**Pier 26 Upland Park Construction – Sitework, Demolition, and Concrete  
Project/Contract #C4891-B  
Addendum # 4  
December 3, 2018**

**3. Attachment A of the RFP contained in the Project Manual is hereby amended as follows and as specifically set forth in Attachment 1 herein:**

**(A) "1. C4891 –A-E Pier 26 Upland Park Construction" is amended to include the following drawing modifications:**

**(B) "4. C4981-B Sitework, Demolition, and Concrete – Specifications" is amended to include the following specification modifications:**

**L-403.00**

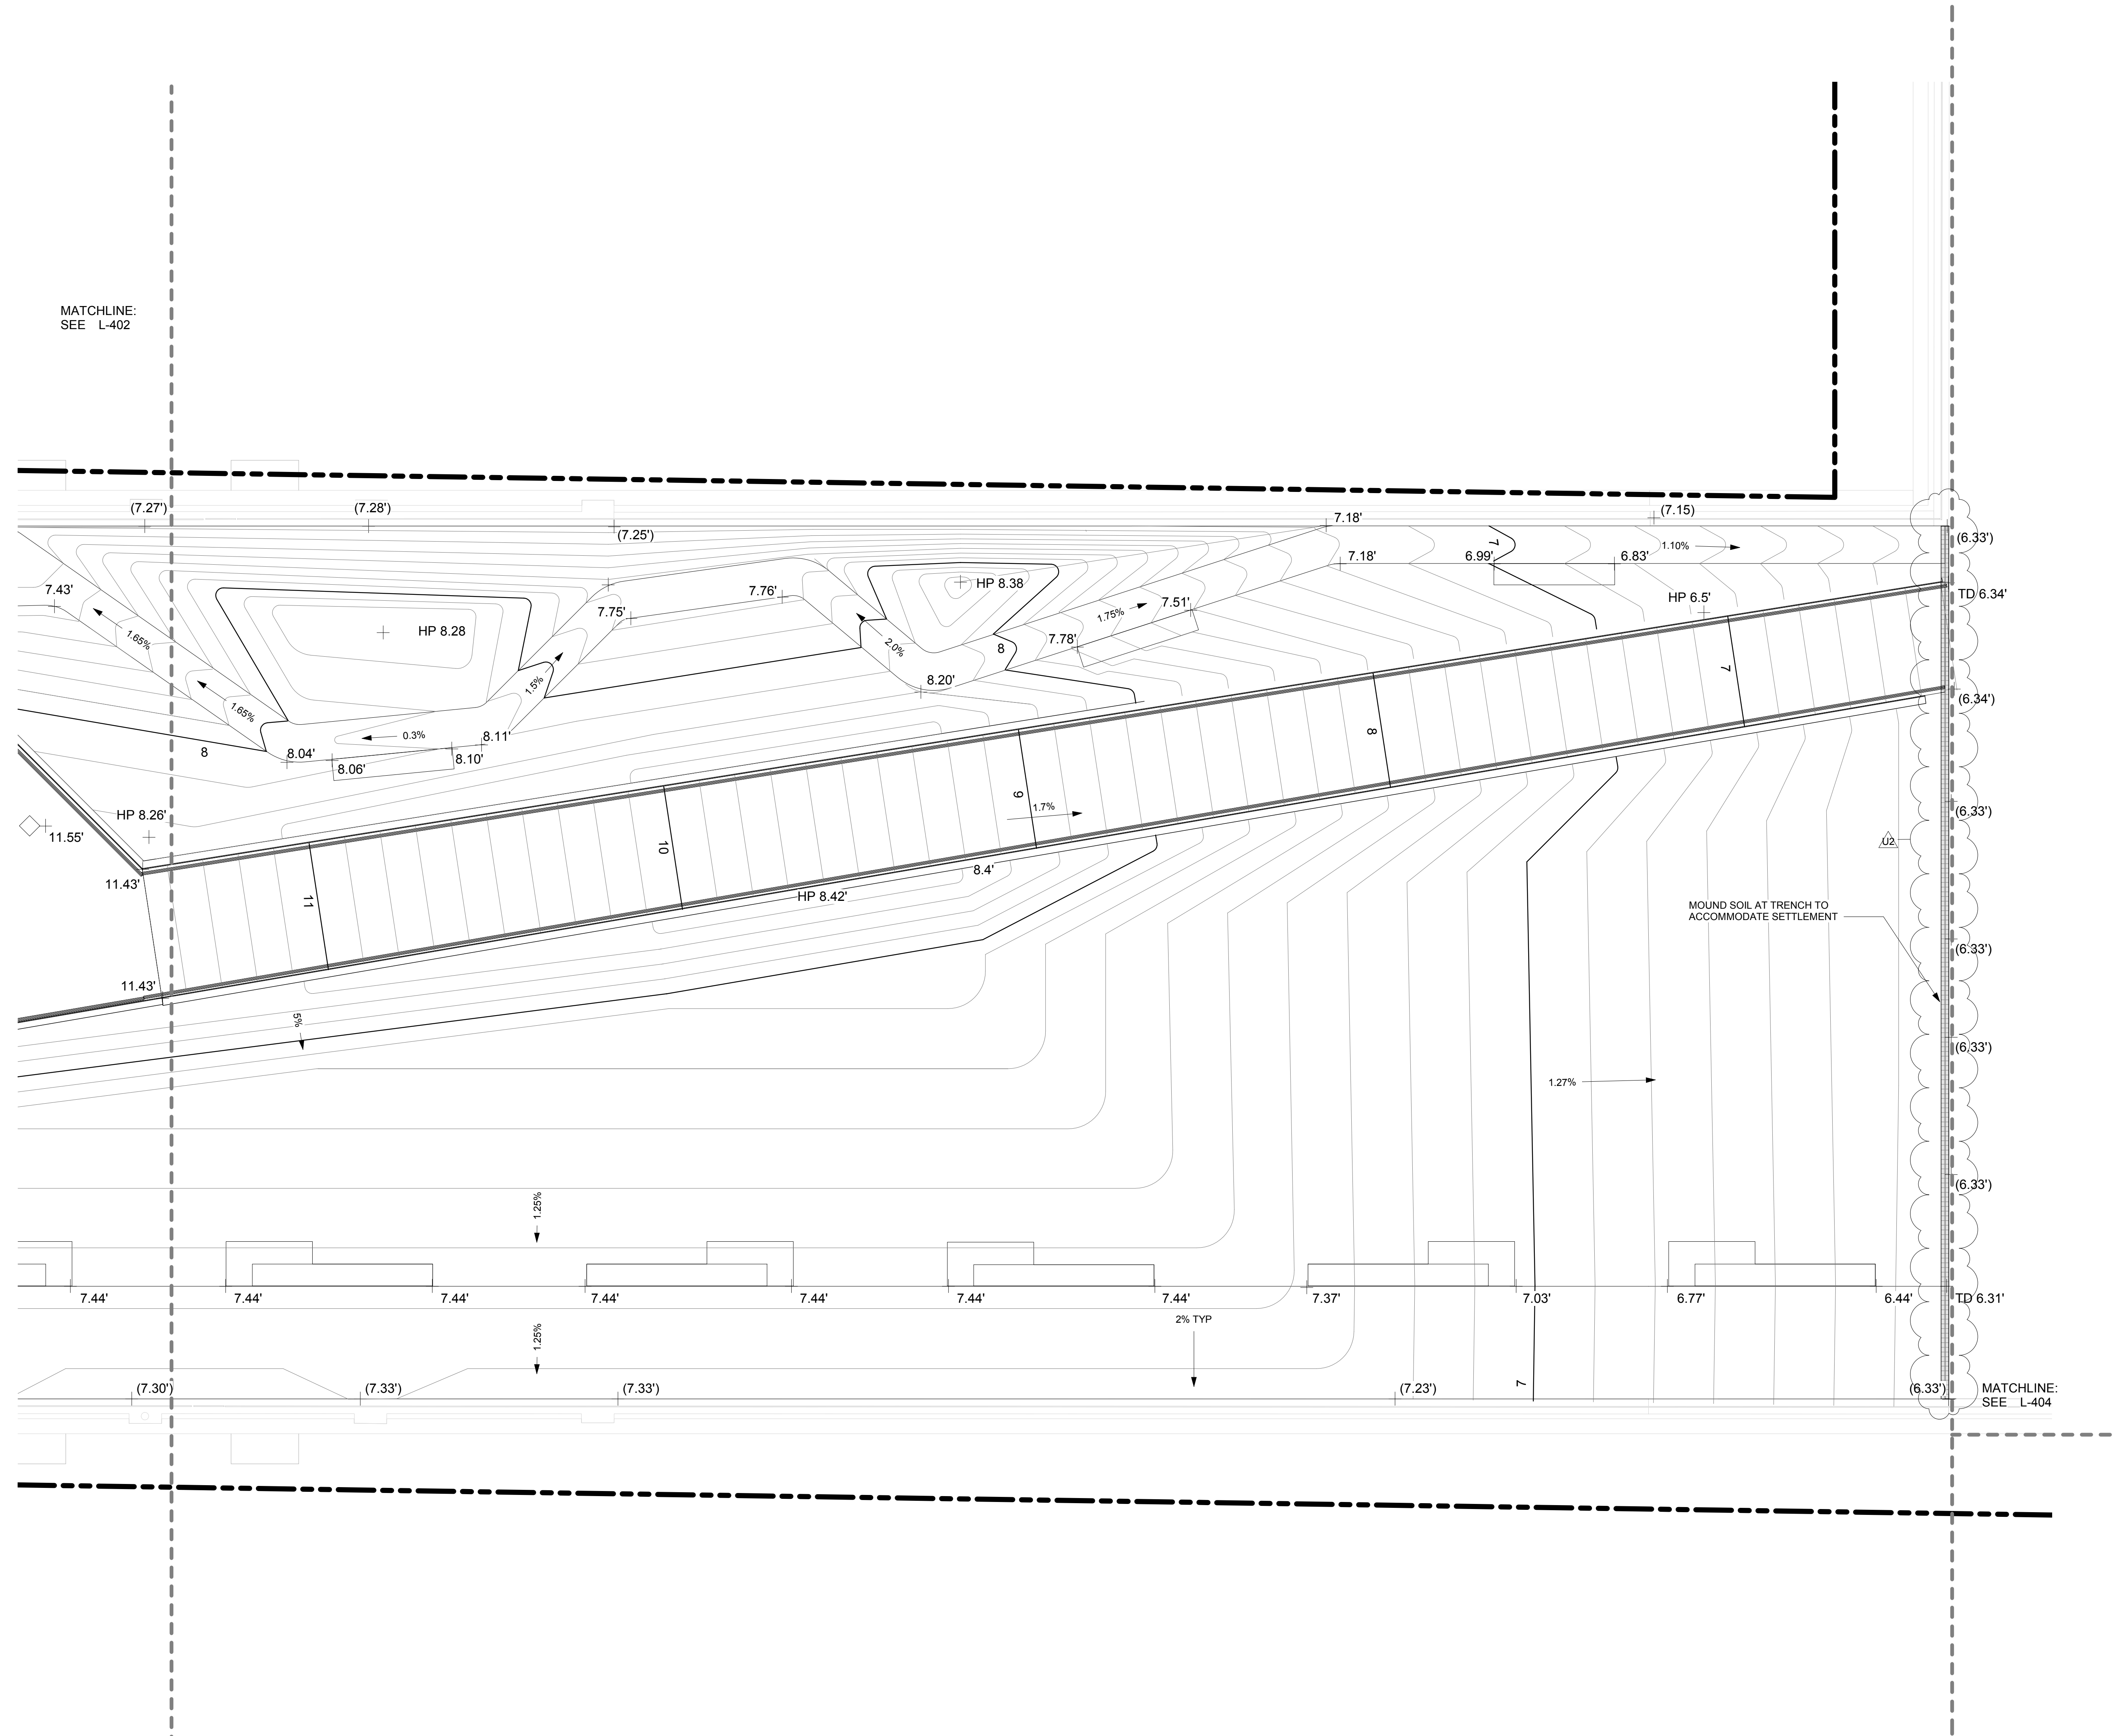
L-402 - GRADING PLAN - PIER C	Symbol for slot drain and trench drain has increased visibility.
L-403 - GRADING PLAN - PIER D	Symbol for slot drain and trench drain has increased visibility.
L-404 - GRADING PLAN - NORTH UPLAND	Symbol for slot drain and trench drain has increased visibility.
S-301 - FRAMING PLAN - PIER B	Walkway south of seating terrace no longer called out as 8" concrete seating step.
S-302 - FRAMING PLAN - PIER C	The thickness of the concrete is correctly labeled to show the 8" depth only at the 15' wide southern, as in the materials plans.
E-301 - ELECTRICAL PLAN - PIER B	Location of Q-vault shown.
E-302-ELECTRICAL PLAN - PIER C	Electrical clarification to sport pole.
E-308 - WOOD AND STEEL SHED ELECTRICAL DETAILS.pdf	New sheet showing clarifications of electrical work at the sheds.
P-303 - SANITARY PIPING PLAN - PIER D	Cross section of piping added.
P-312 - SANITARY PIPING PLAN - PIER C	Clarification to boat service utilities.
